REPORT TO THE PLAN COMMISSION

Meeting of February 6, 2020

Site Plan

SUBJECT: City of Franklin Corporate Park Sewage Pumping Station – Site Plan Application Comments

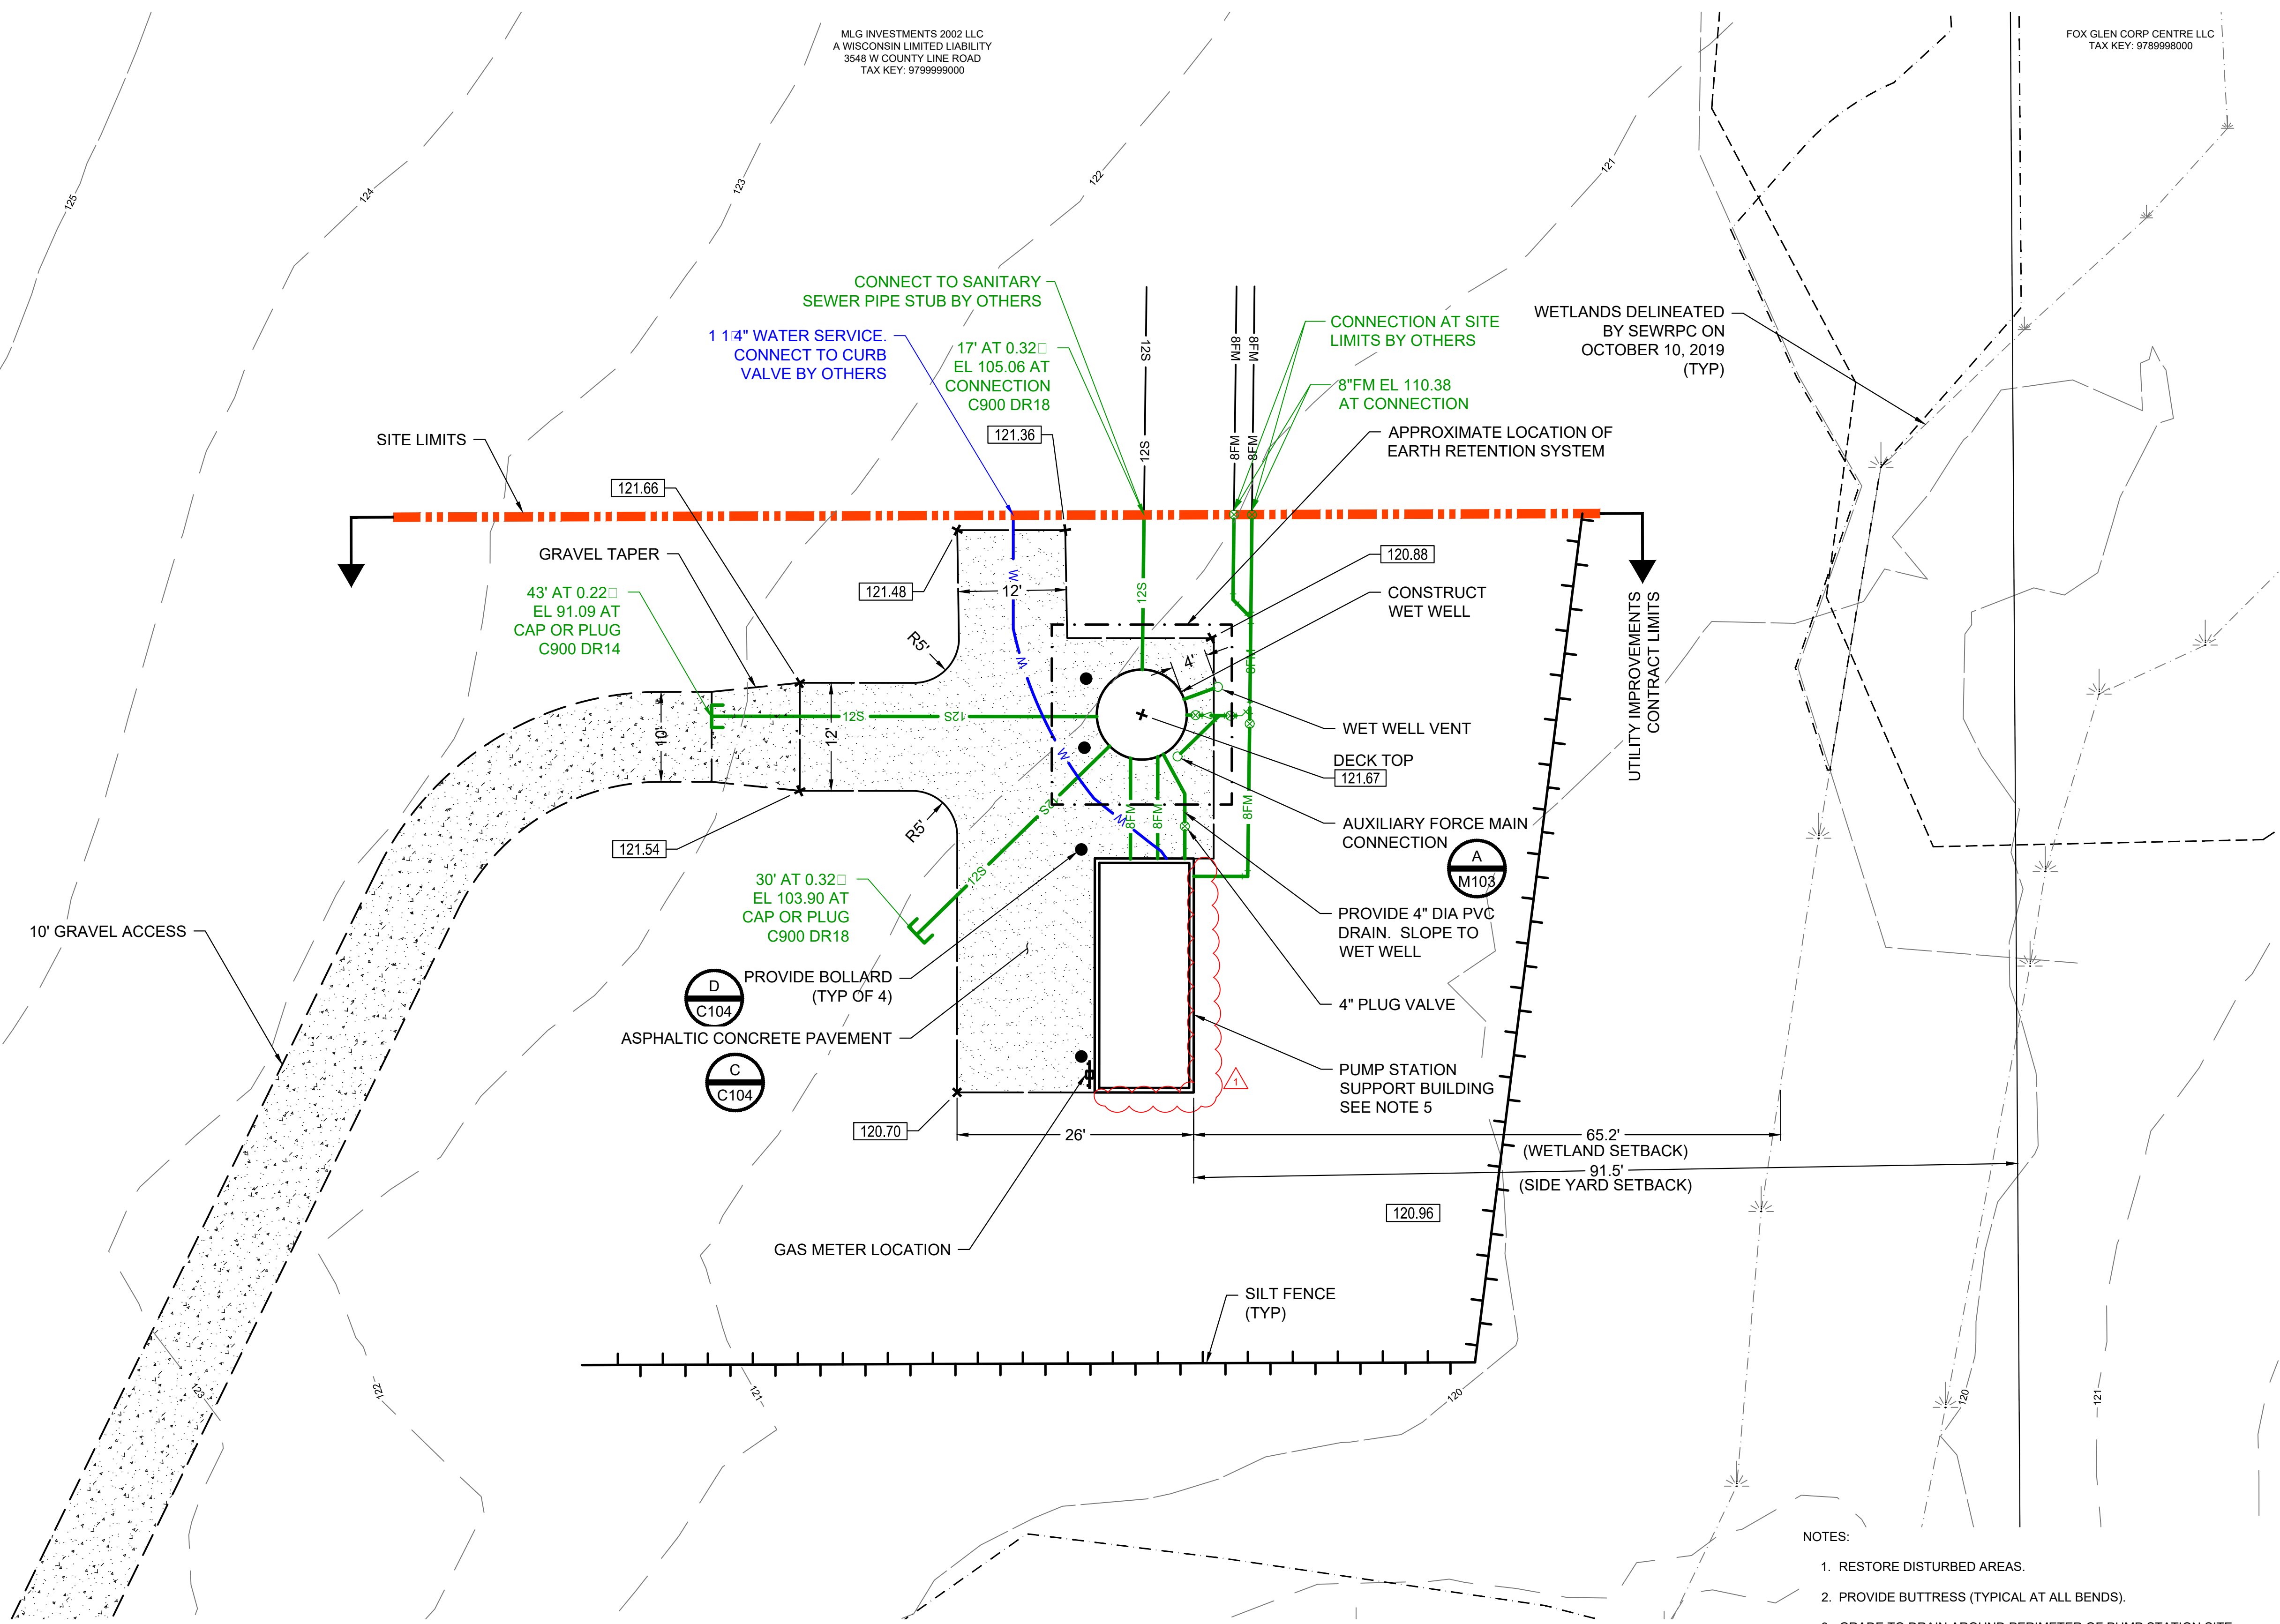
1. Pursuant to the Unified Development Ordinance (UDO) Section 15-7.0103, please provide the following:
M. **Setbacks.** Please add wetland setback and rear yard setback.

Wetland, rear yard, and side yard setbacks were added to Sheet C102R-1 which is included in this submittal package.

SHEET NO.
C103R-1

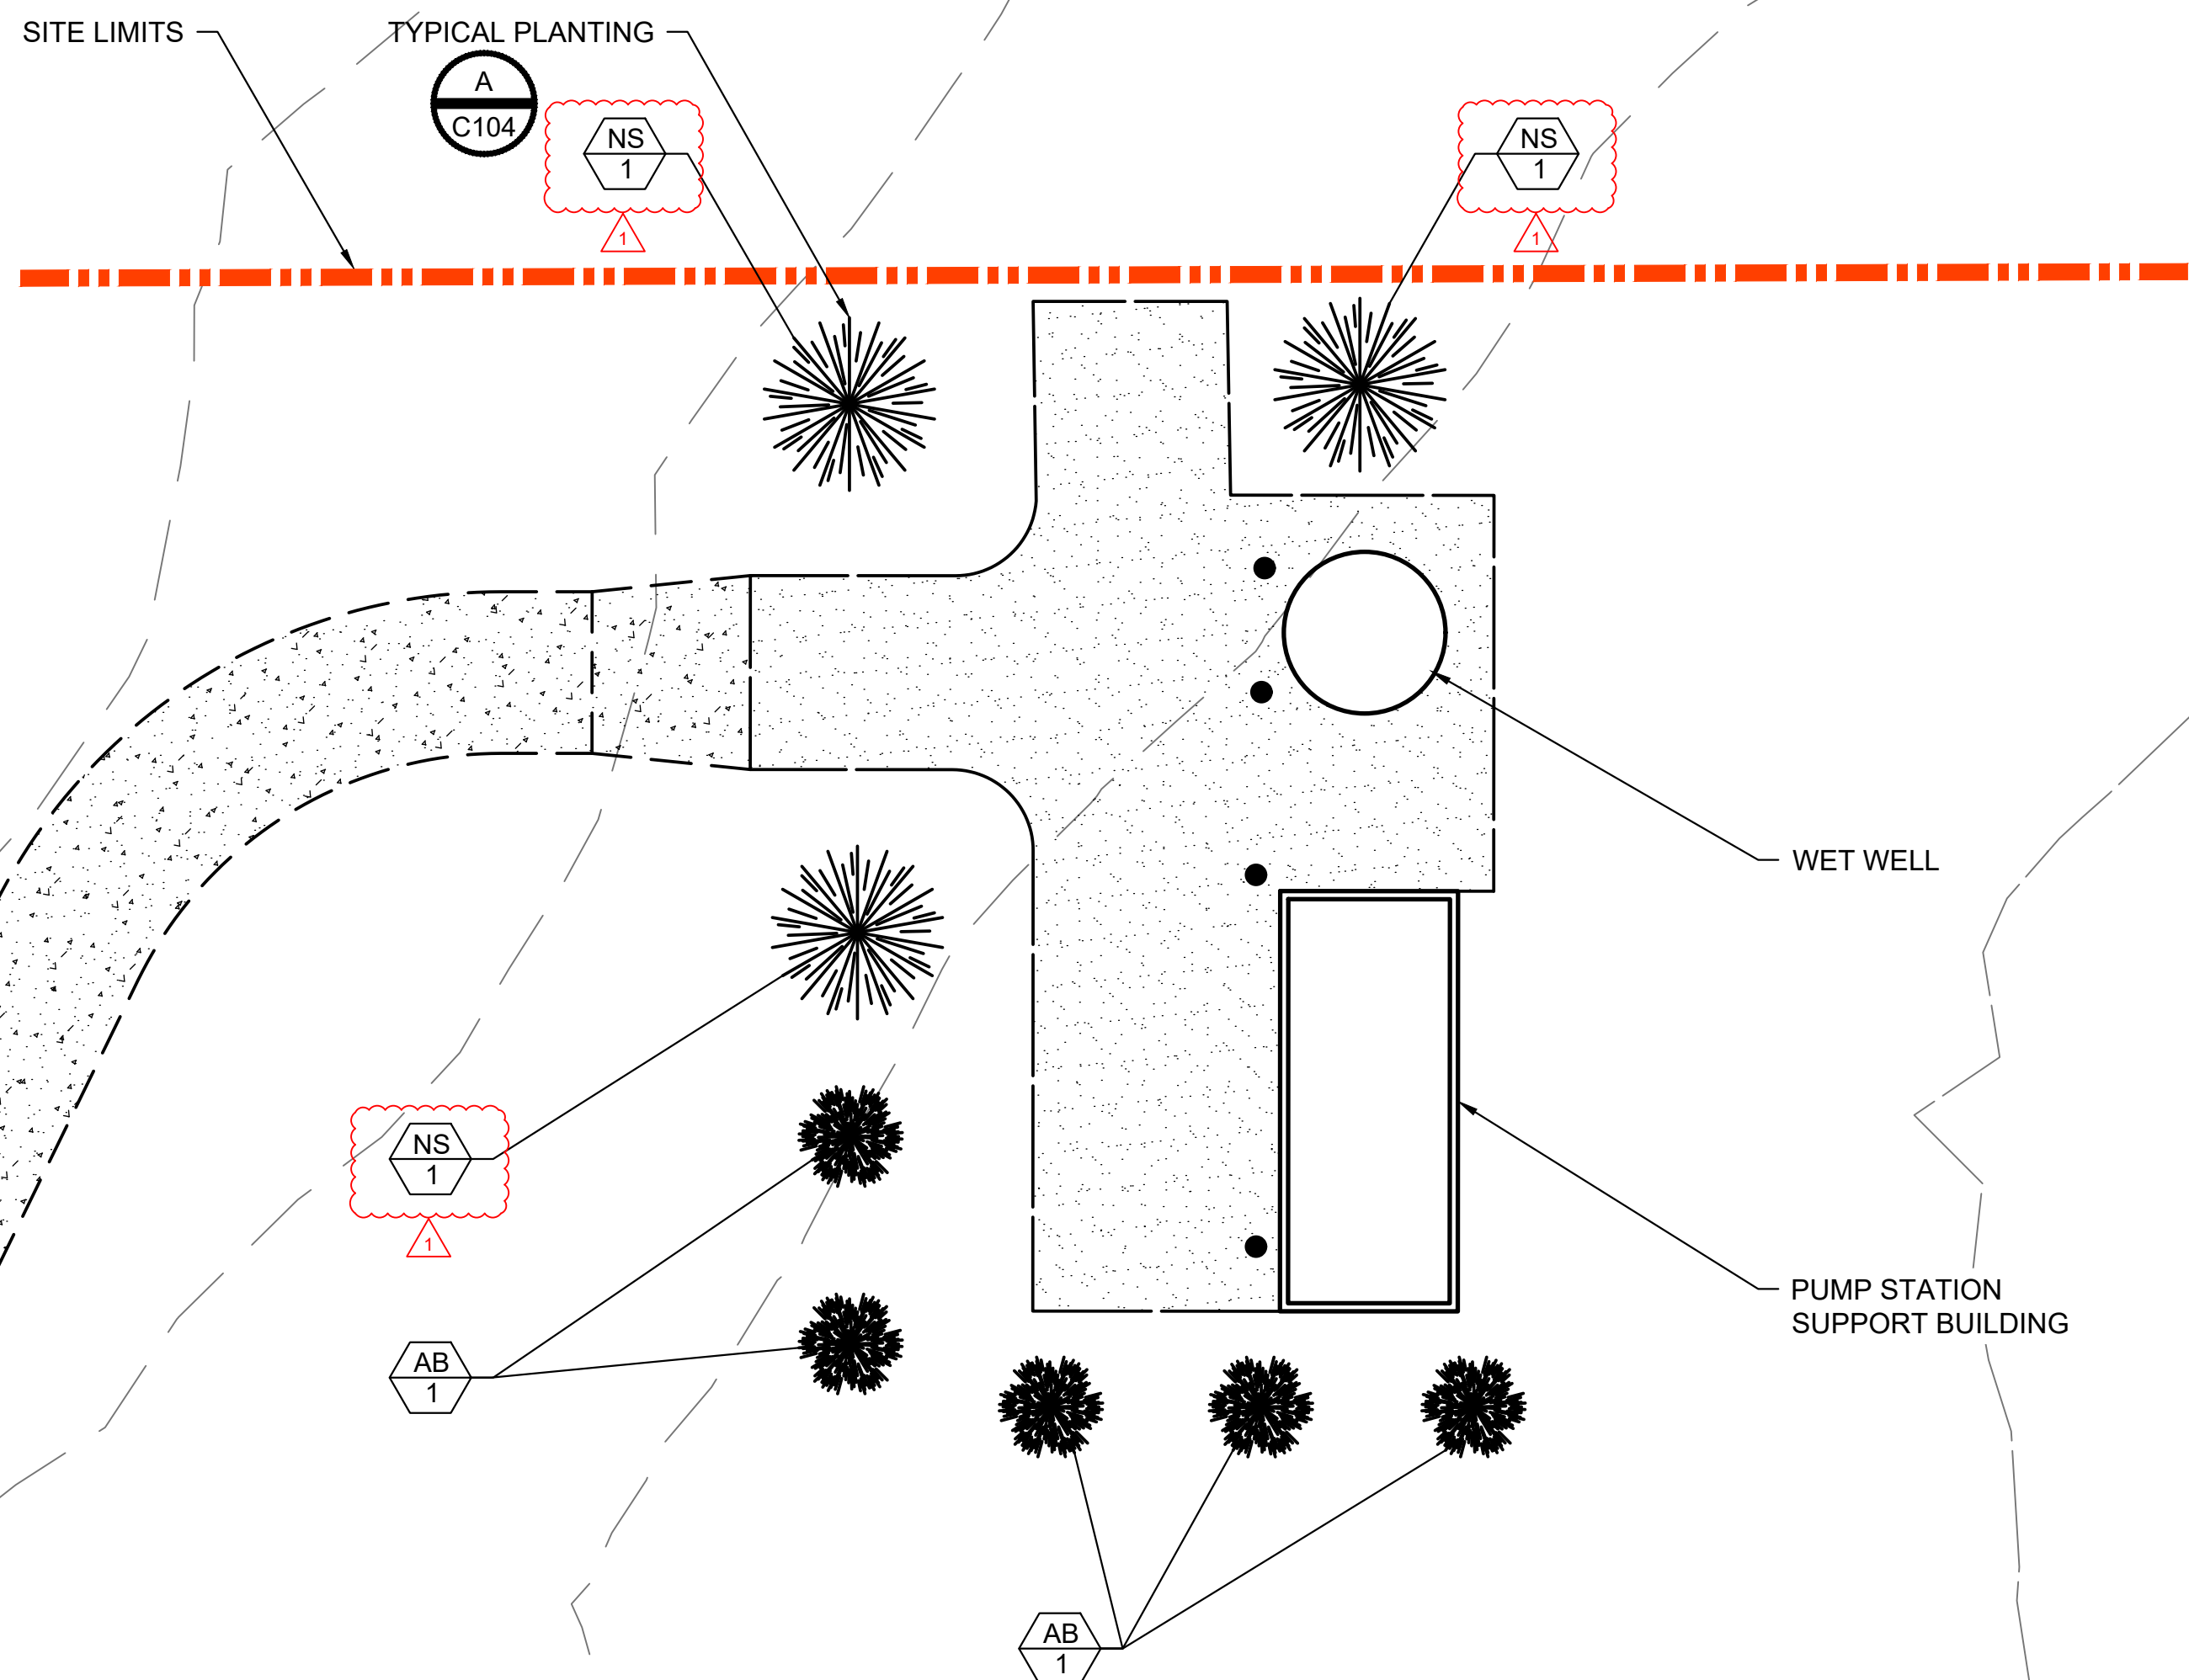
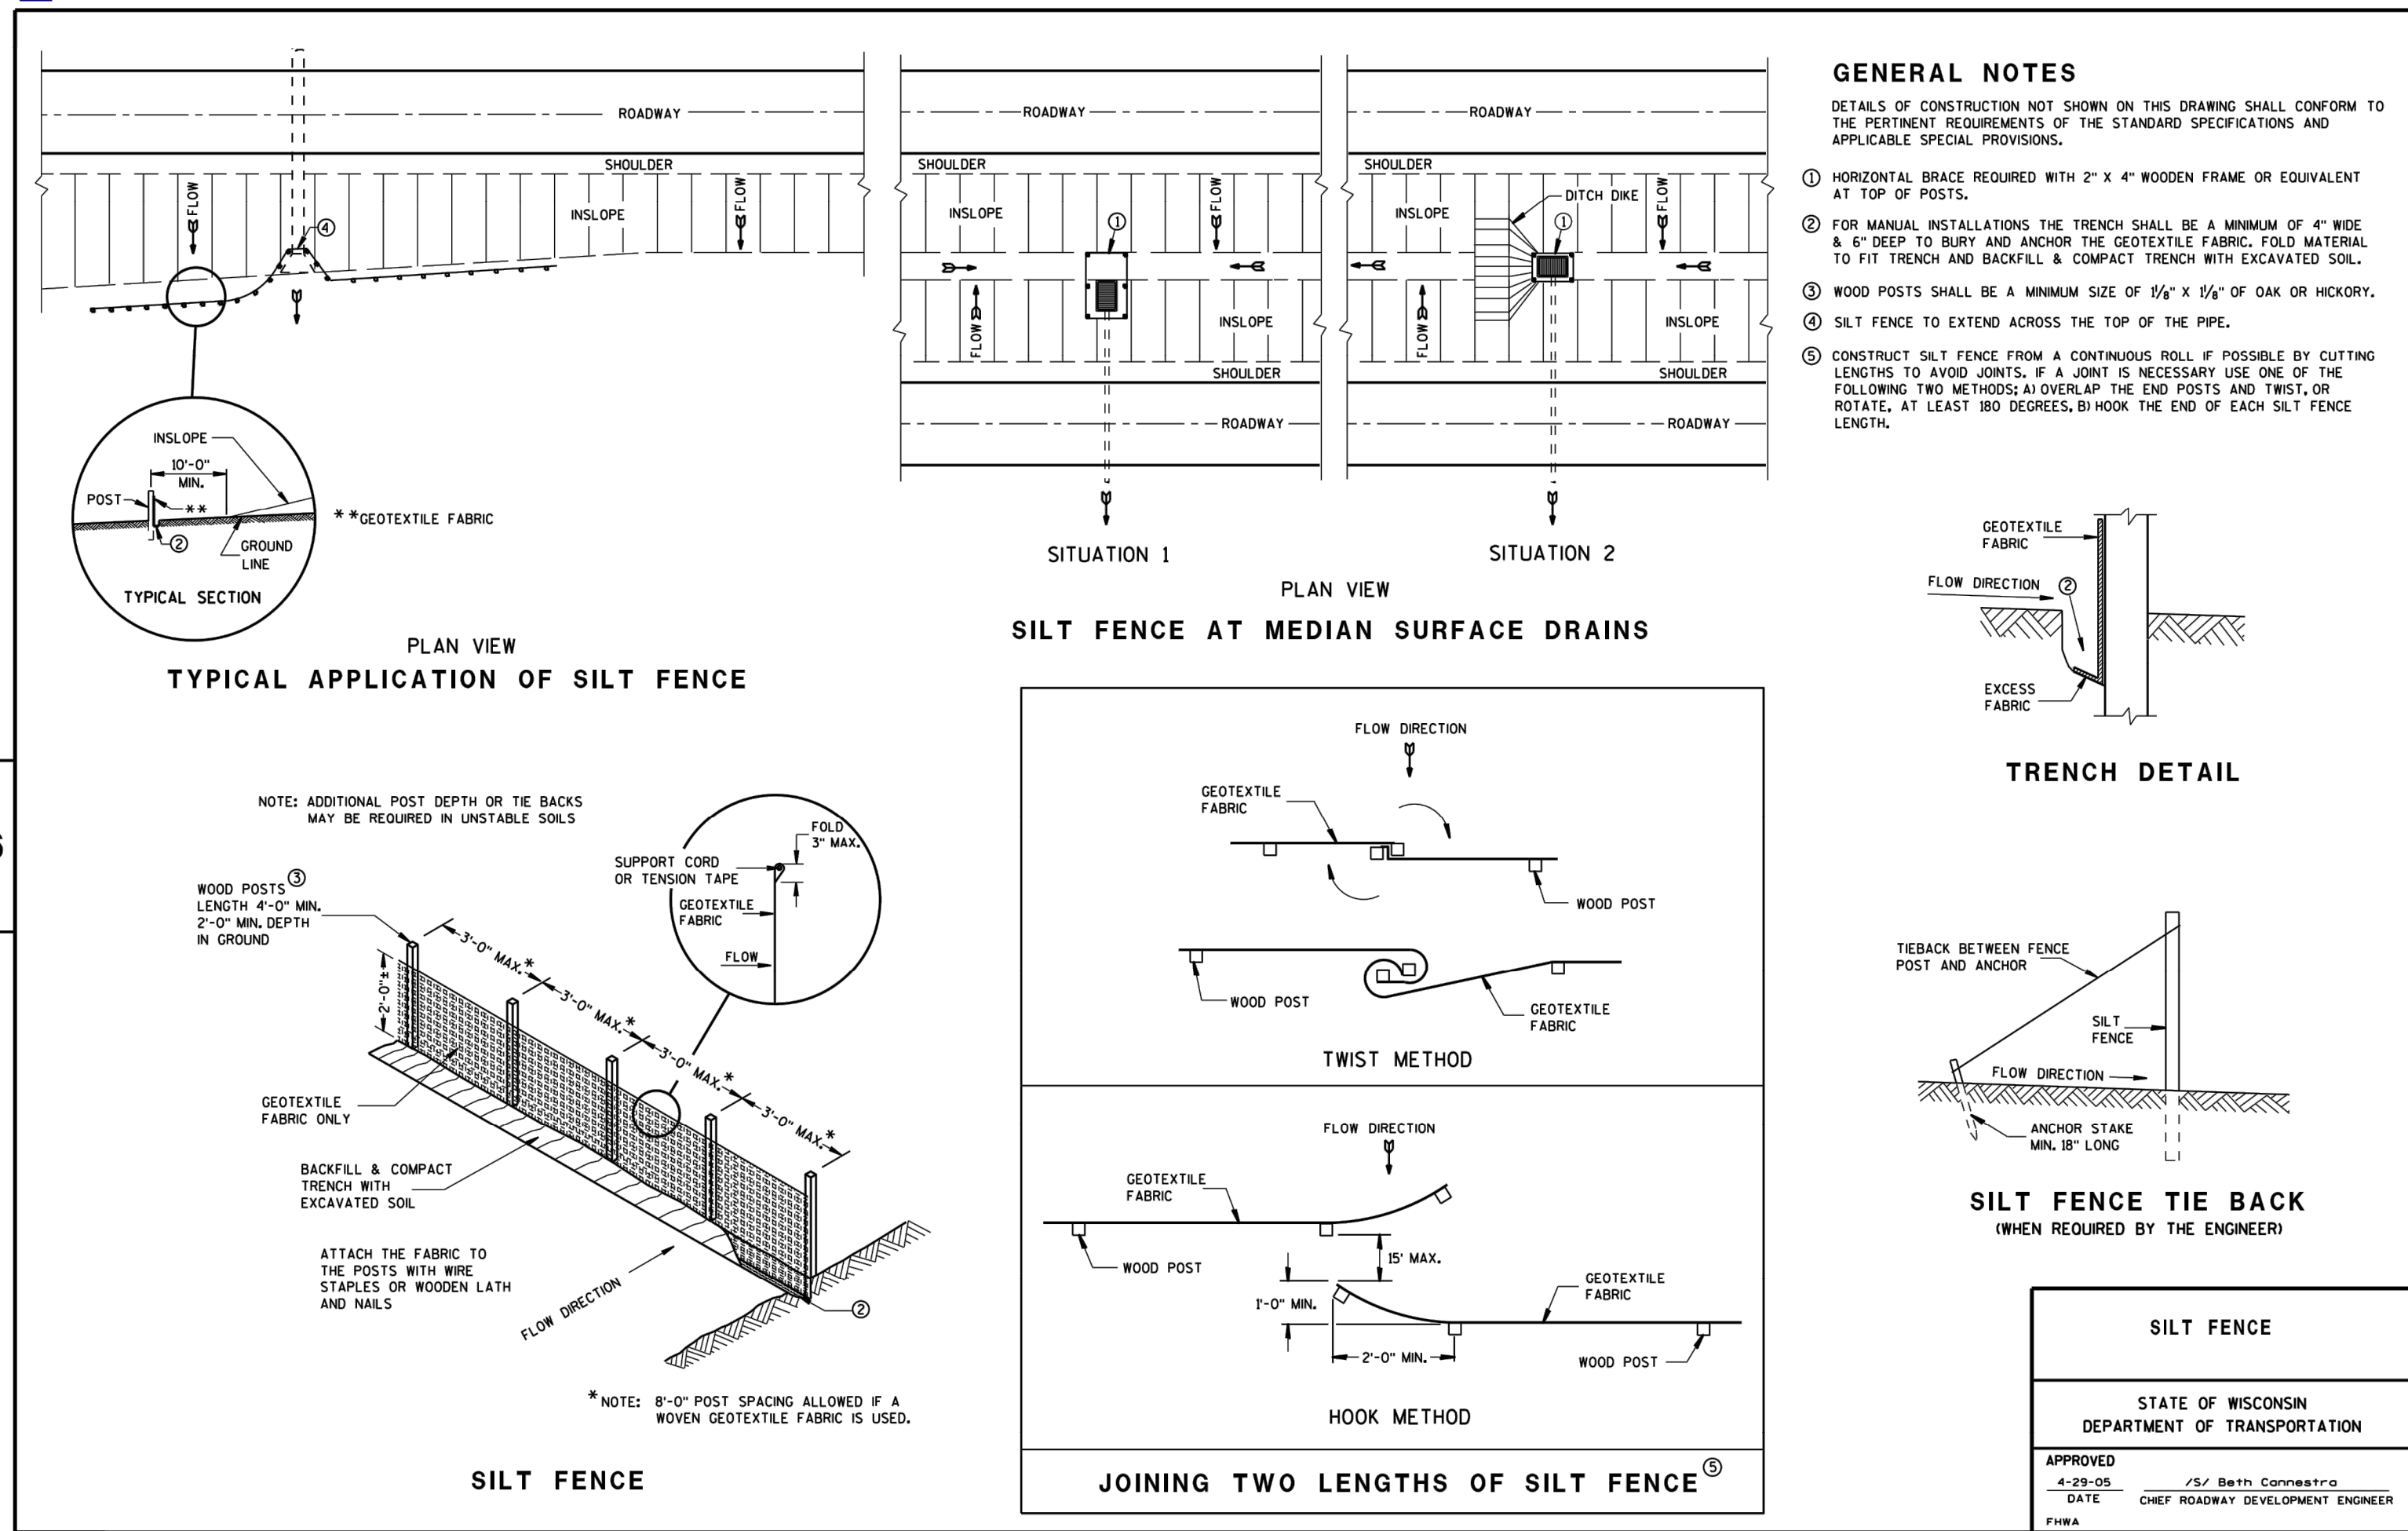
2. It is noted that per UDO Section 15-5.0303, irrigation is required for all new landscaped areas. Does this project include irrigation? If not, you may request a waiver of this requirement to the Plan Commission.

Per Glen Morrow, he would like to use a similar approach to the Waukesha building project recently reviewed by the Plan Commission. In this arrangement, the City is willing to provide a 2-year guarantee on the landscaping.
